**Proposed Category Map Amendments: Montgomery County Comprehensive Water Supply and Sewerage Systems Plan – Three Water/Sewer Service Category Change Requests – April 2020 County Council Cases**

Montgomery County Comprehensive Water Supply and Sewerage Systems Plan – Three Water/Sewer Category Change Requests

**COMPREHENSIVE WATER SUPPLY AND SEWERAGE SYSTEMS PLAN AMENDMENTS**  
**County Executive's April 2020 Transmittal Packet**  
**FY 2019 Category Change Requests**

**Sewer Main Extension: Contract No. 1997-2032A (Built 1999)**

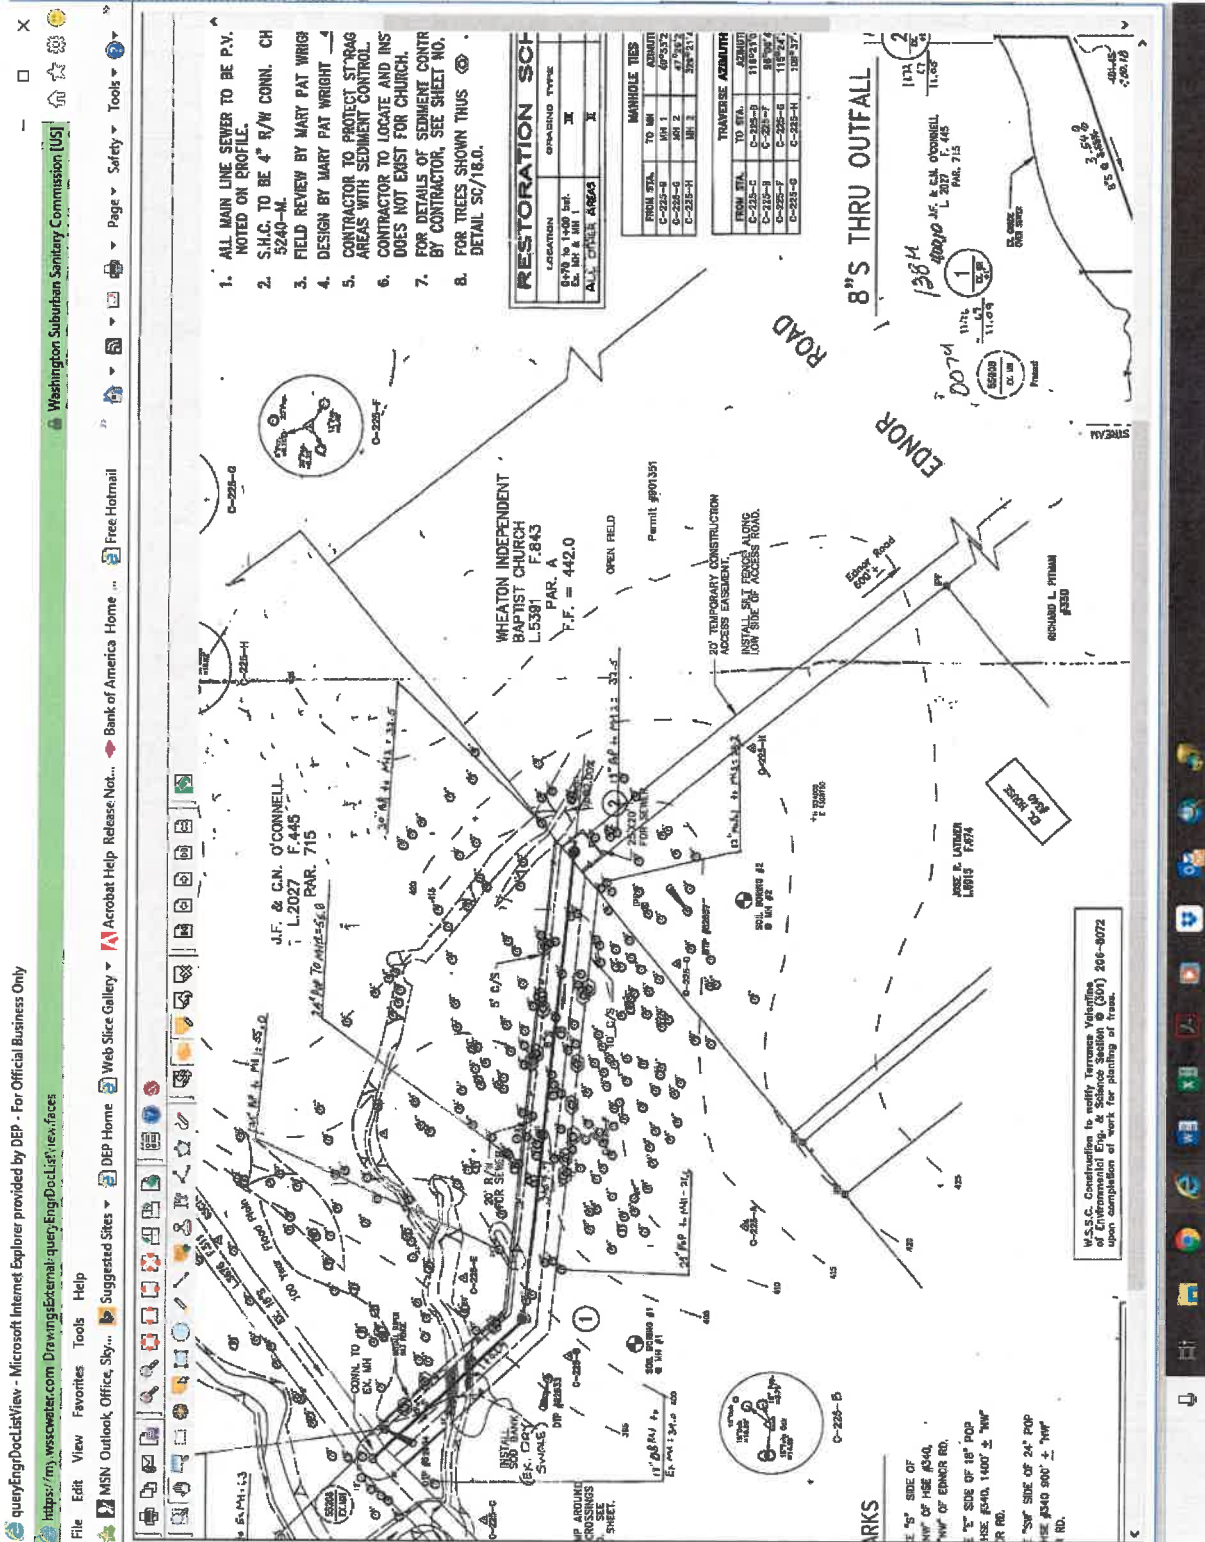
The applicant seeks approval for a sewer category change from S-6 to S-1 to allow public sewer service for an existing single-family house. An existing WSSC sewer manhole abuts the northeast corner of the property from which WSSC could install a sewer service connection for the applicant's property. The property existed at the time the abutting sewer main and manhole were installed in 1999, a condition required for compliance with the Water and Sewer Plan's abutting mains policy.

The sewer main abutting this property was constructed for the adjacent institutional use, Hampshire View Baptist Church, approved for public sewer service under the Plan's private institutional facilities (PIF) policy under CR 13-692 in October 1996 (see page 28). New mains constructed for PIF-based cases are not intended to provide public service to properties not otherwise intended for public service, such as the subject parcel. The original sewer extension proposal for the church's property would have satisfied this requirement (See the map on page 8). However, the constructed sewer extension approved by WSSC was relocated to the southwest and as a result now abuts the subject property. Although not originally intended, the subject property does abut and predate the existing sewer main and should qualify for category S-1, restricted to only a single sewer hookup. At 2.0 acres in size, the property cannot be subdivided into more than one lot under the existing RE-2 Zone.

Page 9

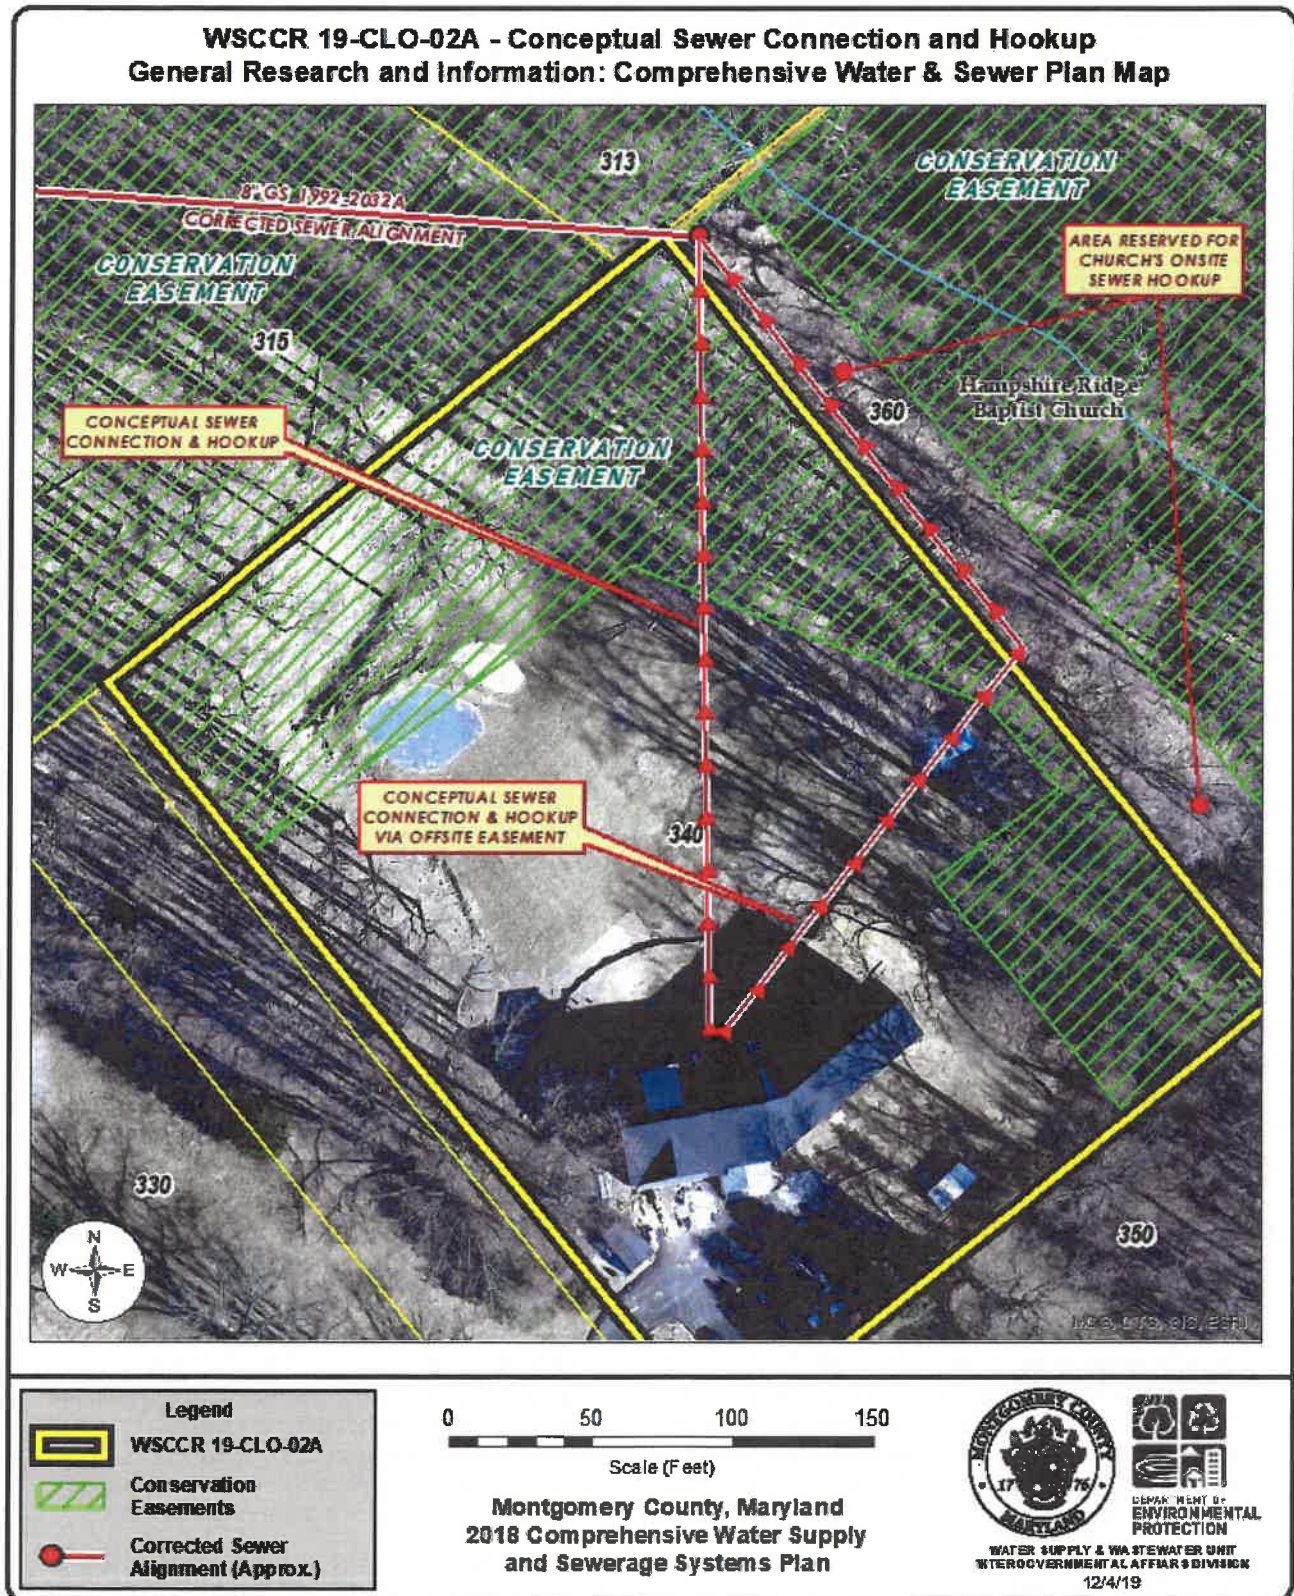
The most direct connection to the existing home will require disturbance to wetlands and forest that have been protected by a Category I conservation easement. A less impactful connection may also be possible but require disturbance on the adjacent property, albeit within a utility corridor. See page 9 of Attachment A.

**M-NCPPC – Planning Dept.** The Sandy Spring/Ashton Master Plan shows this property to be outside the approved sewer and water service envelope. It appears that the nearest sewer infrastructure is on the adjacent Church property, an extension that was likely provided under the PIF policy and not for use by the surrounding neighborhood. An extension from this manhole would likely require forest removal within an existing Category I Conservation easement. The applicant has provided no justification for the necessity of sewer service to this property. More information is necessary to adequately assess this request.

**County Executive and Planning Staff Recommendation:** Defer action on the request for sewer category S-3 to allow the applicant time to work out an alignment for the sewer hookup from WSSC's service connection to the existing house. Approval for category S-1 can be considered under the Water and Sewer Plan's "abutting mains" policy.

Page 15

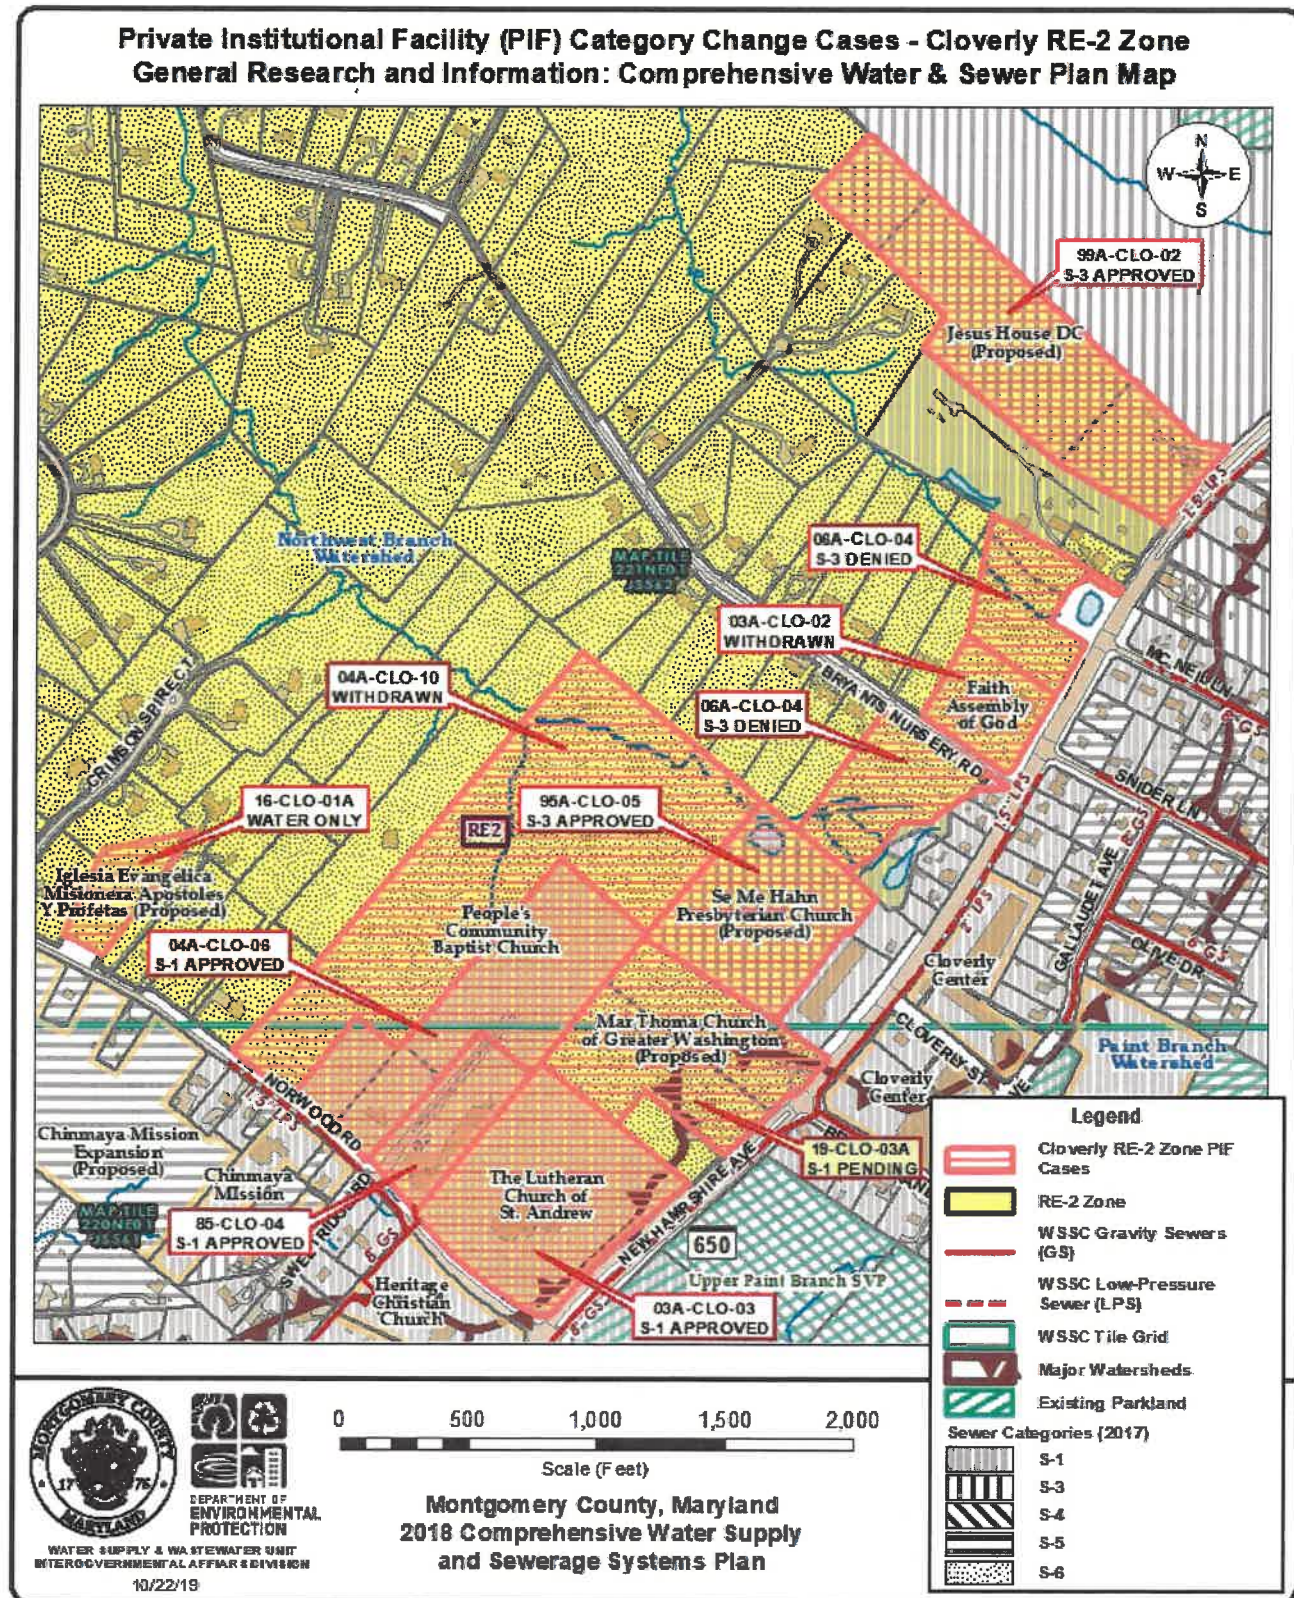
pages 28 - 31). Public sewer service will be restricted to a PIF use only consistent with the Plan's PIF policy. The map shown on page 15 provides an inventory of PIF-based category change requests in the RE-2 Zone in the vicinity of the O'Keefe/Mar Thoma Church request.

**Concept Plan No. 520190160: Mar Thoma Church of Greater Washington**

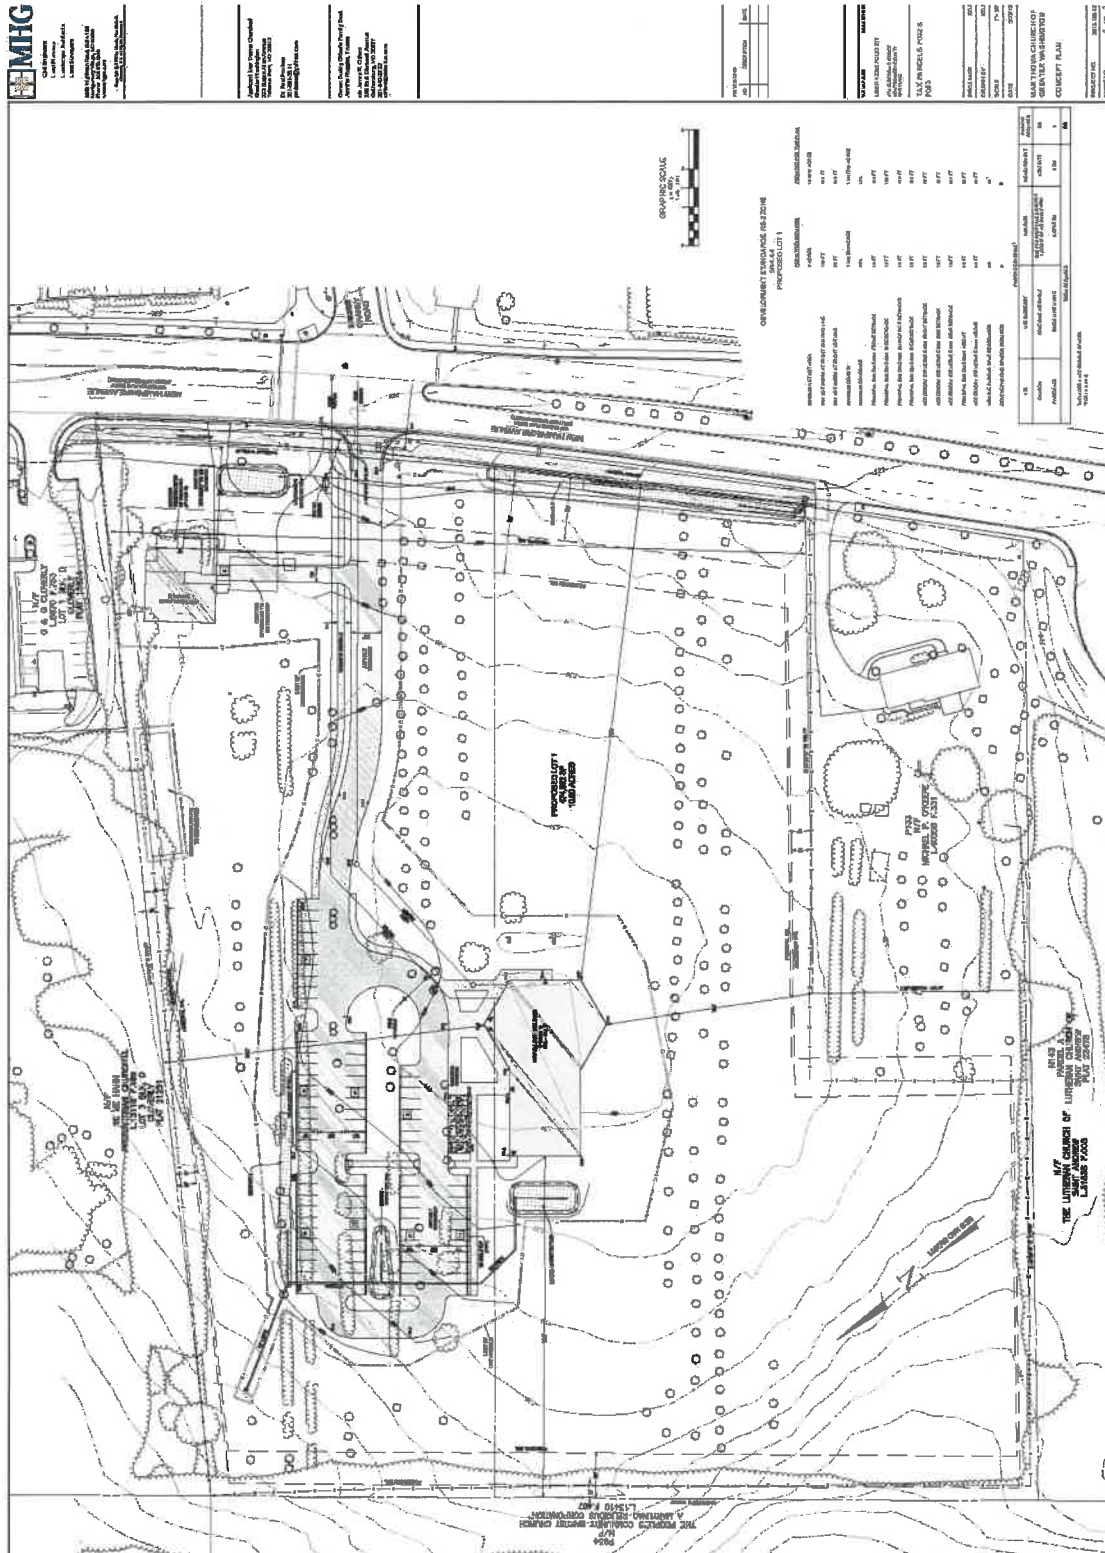
The applicant has previously submitted a Concept Plan to staff for agency review. Agency comments have been submitted and are included with this review. Under the current PIF policy, Council review of proposed category changes will focus on consistency between the concept plan and the applicant's proposed development plan, and on proposed levels of imperviousness. See page 16 of Attachment A.

As now required by the Water and Sewer Plan's PIF policy, a concept plan (520190160 "Mar Thoma Church of Greater Washington") for the proposed project was considered by the County's Development Review Committee (DRC) in July 2019. Agency review comments for that concept plan are provided in the table starting on page 12 - 14. The applicant has also submitted a preliminary plan for this project, no. 120200080, which is pending agency review.

**County Executive and Planning staff Recommendation:** Maintain W-5 and S-6, with final approval for W-1 and S-1 conditioned on the Planning Board's approval of a preliminary plan that substantially conforms to the concept plan (520190160) considered by the Development Review Committee on June 25, 2019. S-1 final approval will be restricted to a PIF use only.

**Preliminary Plan No. 120200080: Mar Thoma Church of Greater Washington**  
**Impervious Area Exhibit: Pink = Paint Branch ■ Gray = Northwest Branch**

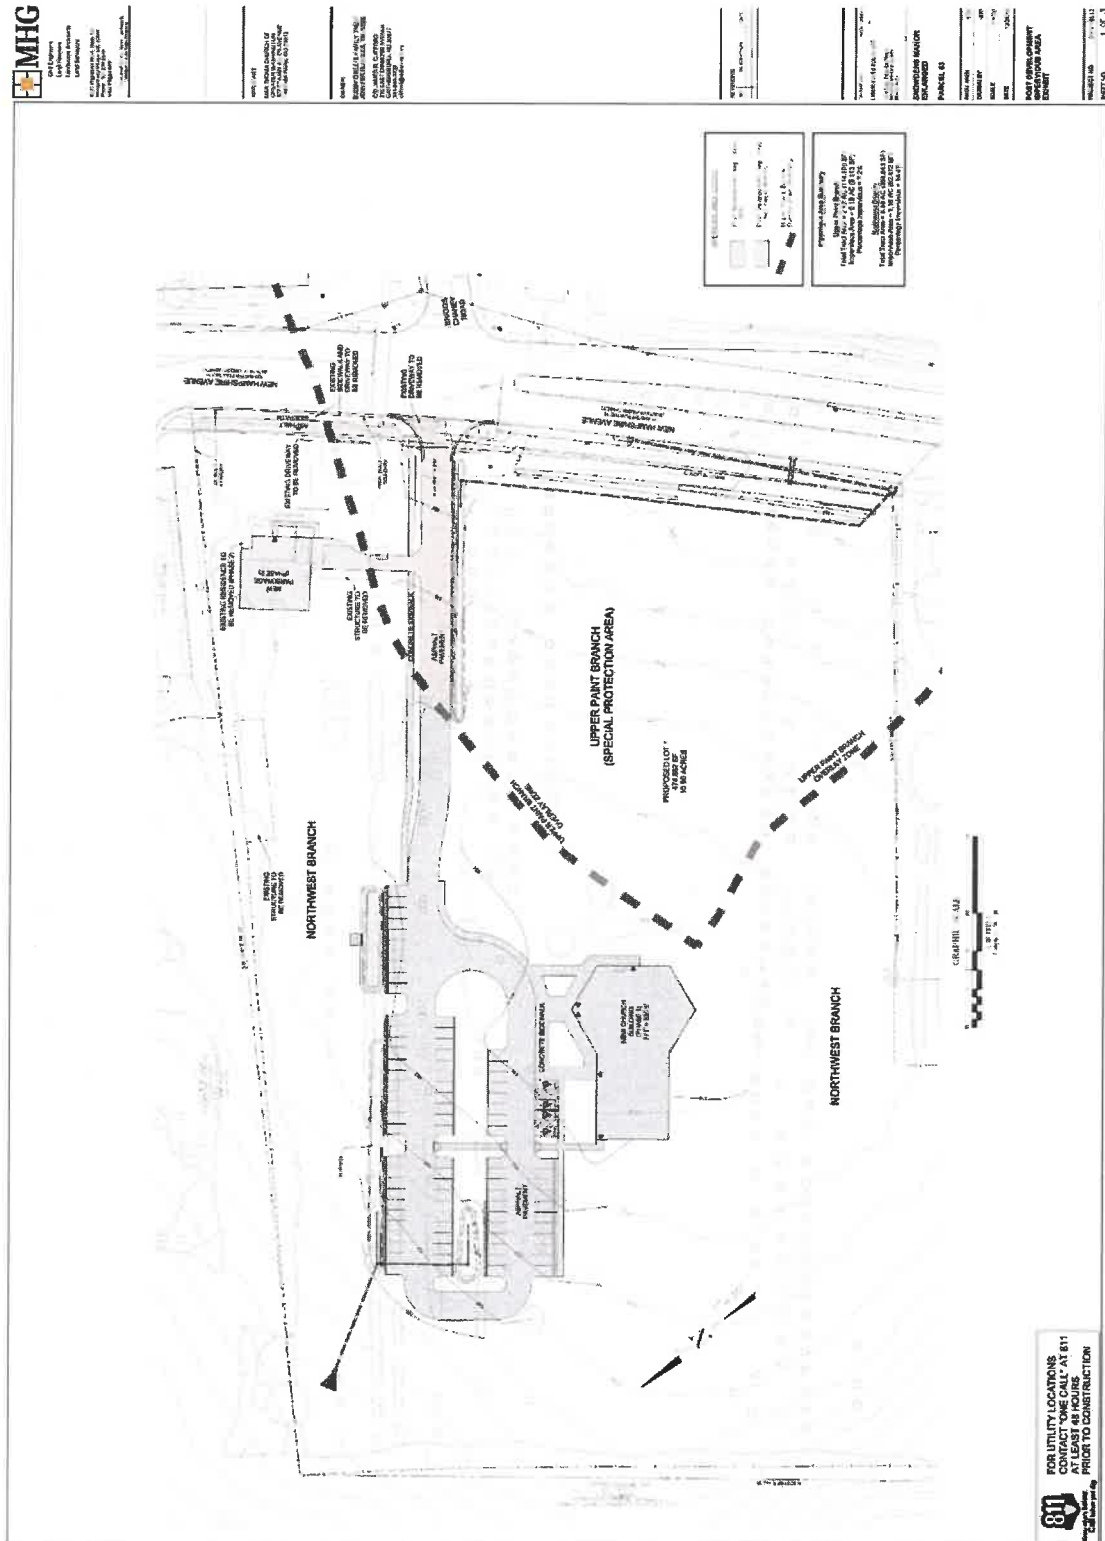
A primary concern for the Council with PIF policy cases has been the amount of impervious area the project creates. This project straddles the Northwest Branch and Upper Paint Branch watersheds. The concept plan proposes an impervious area of 0.19 acres or 7.2 percent of the site area within the Upper Paint Branch Special Protection Area (SPA). This satisfies the SPA impervious area limitation of 8 percent. Impervious area in the Northwest Branch watershed totals 14.4 percent. The Cloverly Master Plan (1997) recommends an overall maximum 15 percent imperviousness for this subwatershed of Northwest Branch. Overall impervious area for the project totals 12.5 percent. The 2005 PIF Working Group report to the Council noted a county-wide average imperviousness in the RE-2 Zone of 9 percent.

Aside from compliance with PIF policy requirements, the Council's concern with PIF-based requests has primarily been the additional impervious area created by these projects as compared to that expected to result from lower-density residential uses. The impervious surface exhibit provided on page 17 is part of the preliminary plan submittal. M-NCPPC staff comments on the concept plan's proposed impervious area are provided in the table on page 14. The site is divided between the Upper Paint Branch and Northwest Branch watersheds. The Upper Paint Branch SPA calls for a maximum impervious area of 8 percent. Overall impervious area within the Bryants Nursery subwatershed Northwest Branch is recommended for between 10 and 15 percent. The following table summarizes the impervious area proposed by this project based on the recently submitted preliminary plan.
